SUBJECT: Parkway proposals

Subject: Acceleration Lane for the Entrance Ramp
to NB George Washington Memorial Parkway
at the CIA-FHWA Federal Area

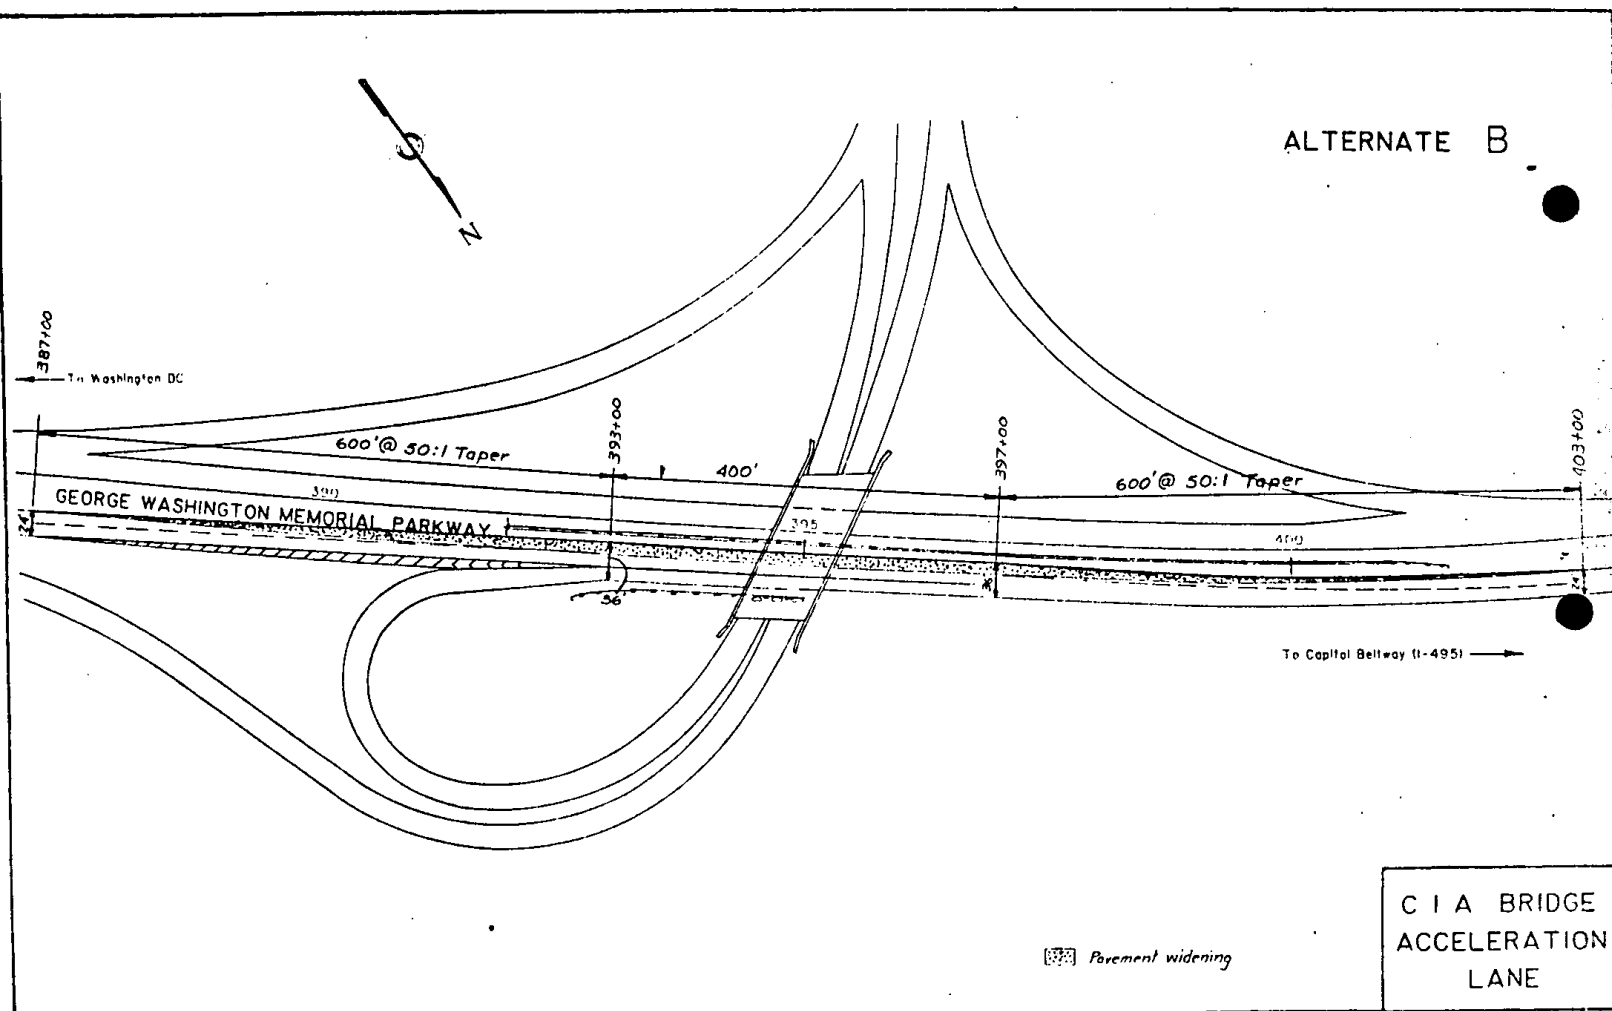
Alternative A is not desirable because of the safety hazard presented to employees by the bridge pier.

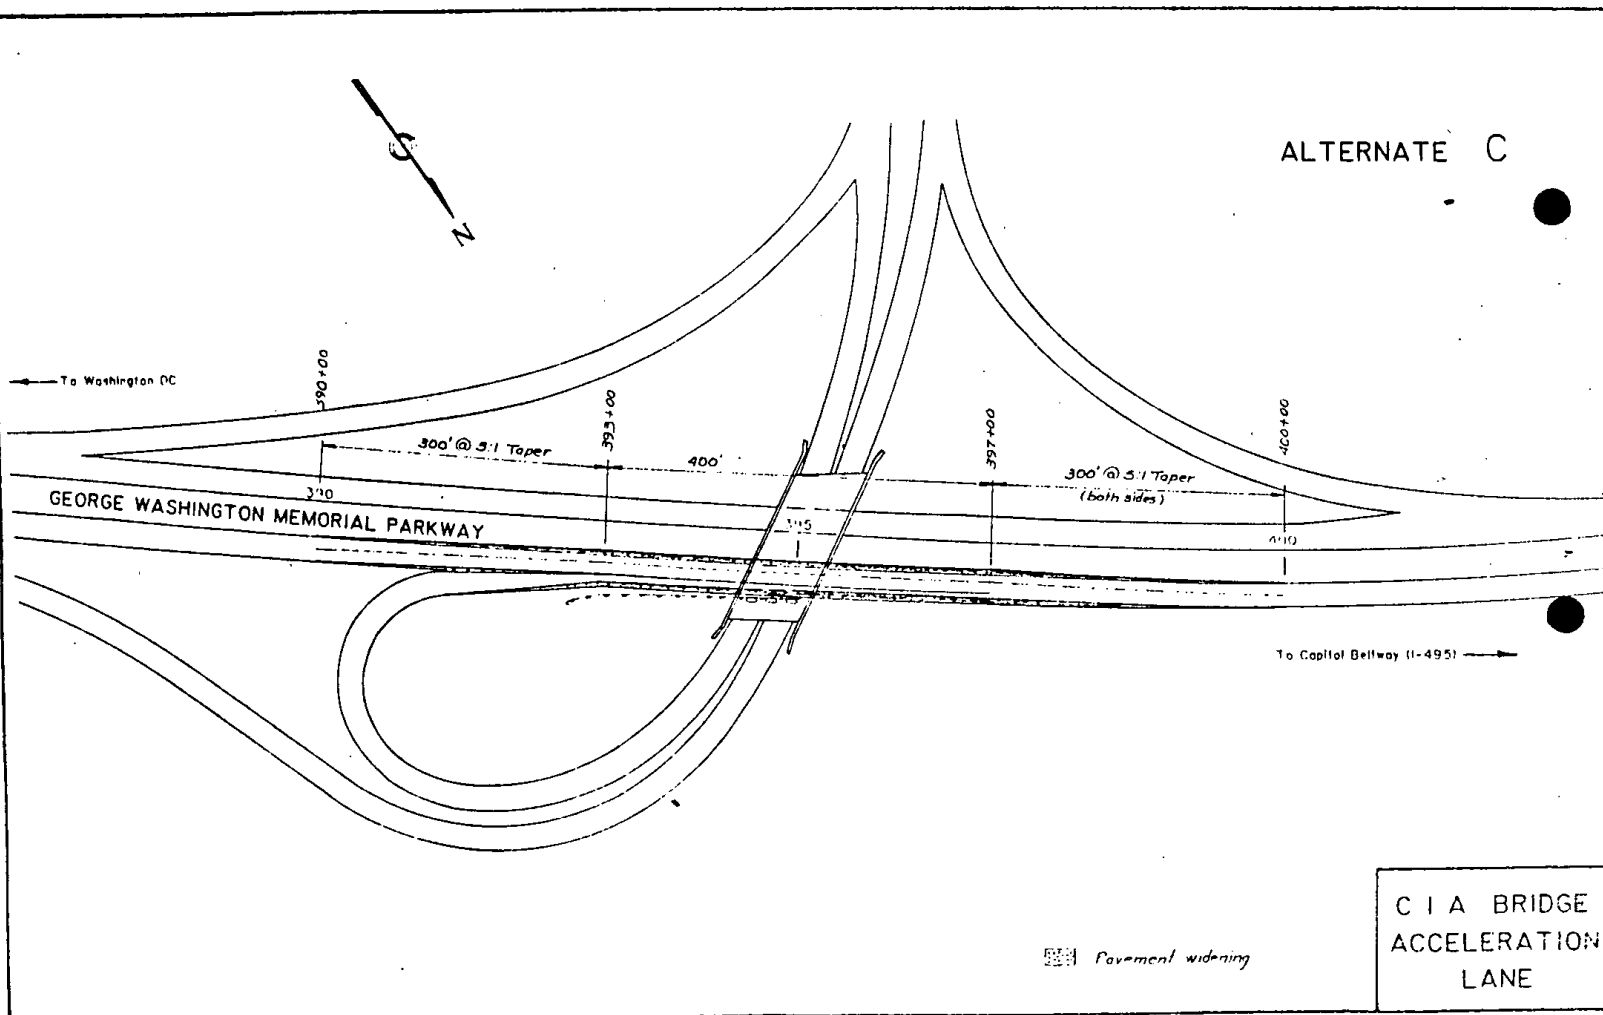
We appreciate Park Service concerns created by the need for a median barrier in option B and therefore rate that the least acceptable of the three remaining options.
